108 GLENDALE DR

INSPECTION OF ENGINEERED SUBSURFACE WASTEWATER SYSTEM

INSTALLATION, CONSTRUCTION, ALTERATION, AND/OR REPAIR APPROVAL

Re: 108 Glendale Drive
File: 1918A
Parcel: 019-281-11

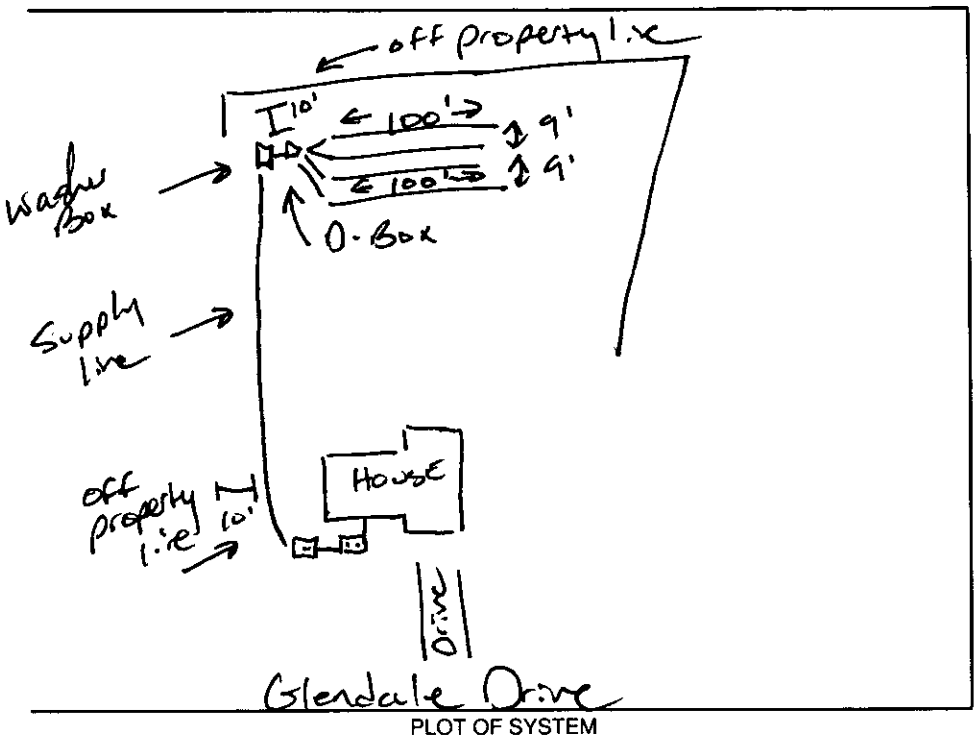
Comments: Type III b 3bedroom house
(4) 3'w x 100'L x 12" stone

* Alarm must have a separate circuit; fusing indoor type
* Pump connections must be made in a Nema 4x rated box at the pump tank.
12" above grade.

INSTALLATION, CONSTRUCTION, ALTERATION, AND/OR REPAIR APPROVAL

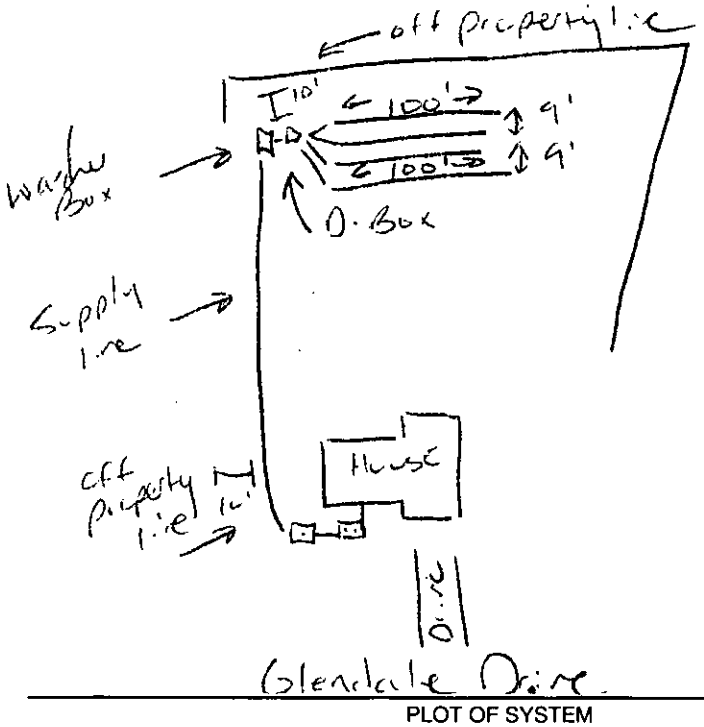
Comments: Type III b 3 bedroom house
(4) 3' x 100' x 12" stone
* Alarm must have a separate circuit fusing indoor type
* Pump connections must be Made in a Nema 4x, rated box at the pump tank. 12" above grade.

SOIL/SITE EVALUATION
for ON-SITE WASTEWATER SYSTEM

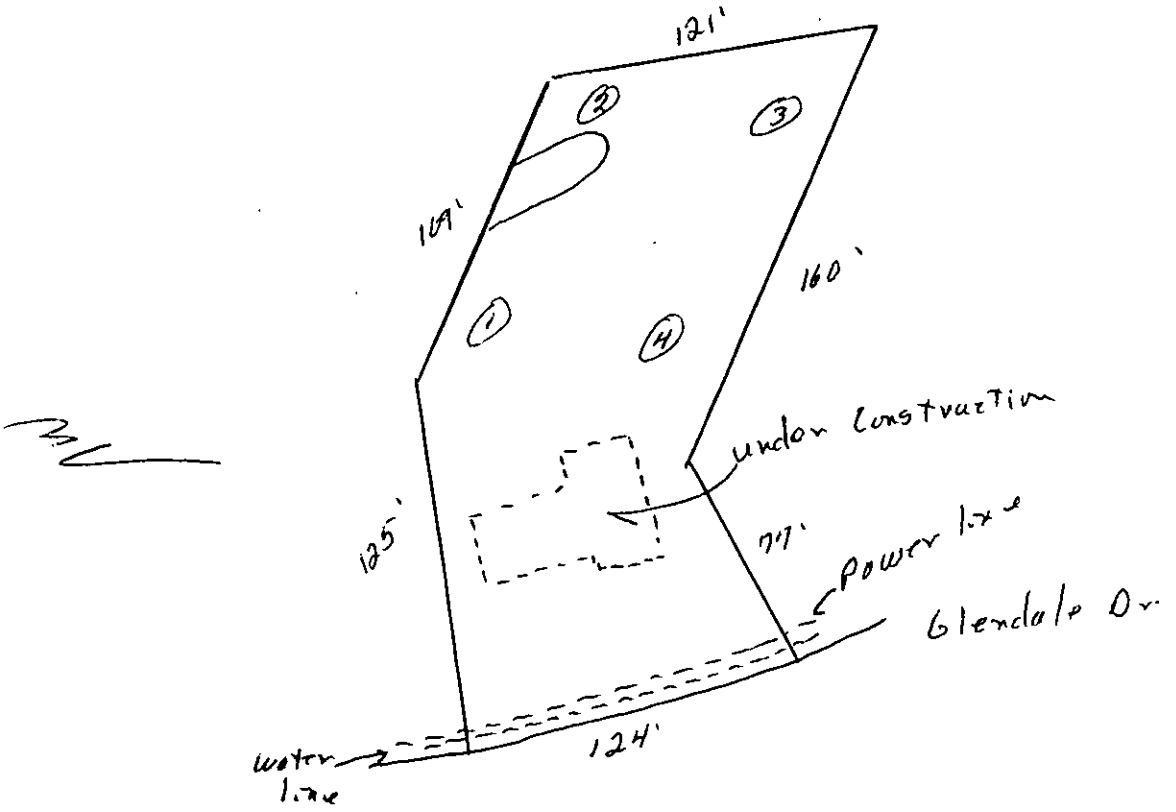
OMMENTS: Lot appears Turned into Uneven - would probably need pump

MECKLENBURG COUNTY ENVIRONMENTAL HEALTH
SITE EVALUATION REPORT
SERIAL NUMBER 11571

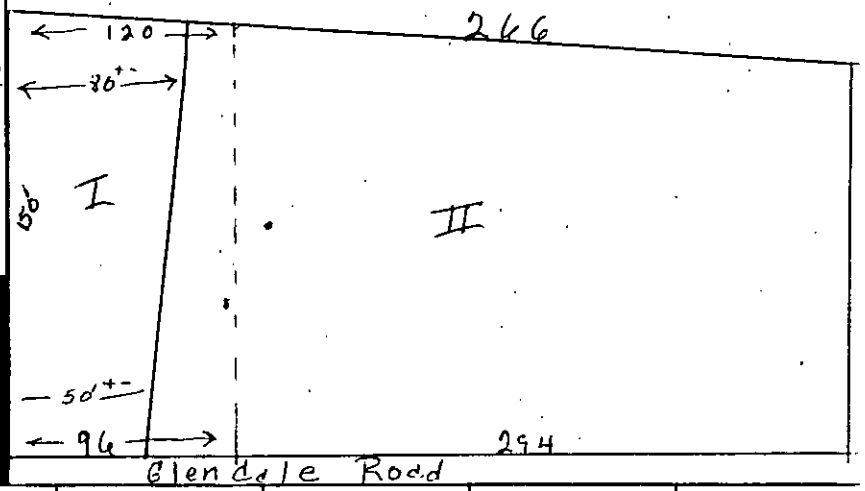
Comments: Area Added To Lot
1- Lift station Required
2- May Not Be Adequate For more Than 300
3- 133' Lines Desirable To Keep system With IN 36" Soil

MECKLENBURG COUNTY ENVIRONMENTAL HEALTH
SITE EVALUATION REPORT
SERIAL NUMBER 11571

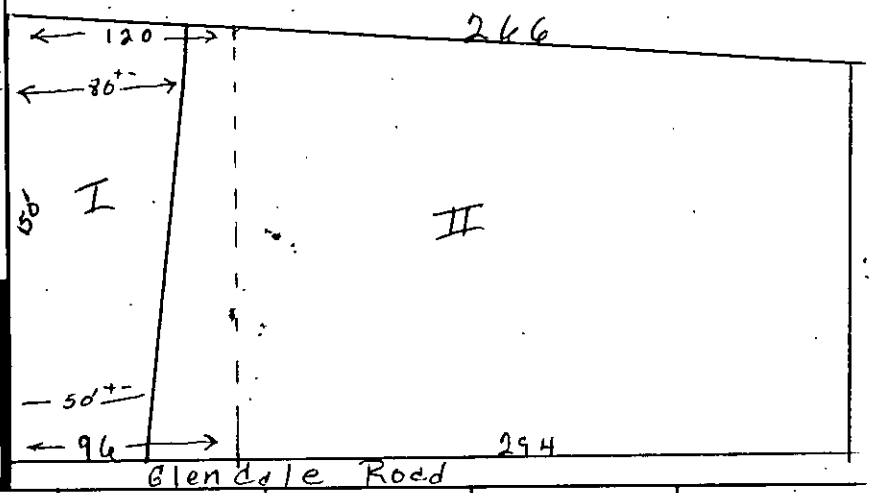
Comments: Area Added To Lot
1- Lift station Required
2- May Not Be Adequate For More Than 38?
3- 133' Lines Desirable To Keep system
With IN 36" Soil
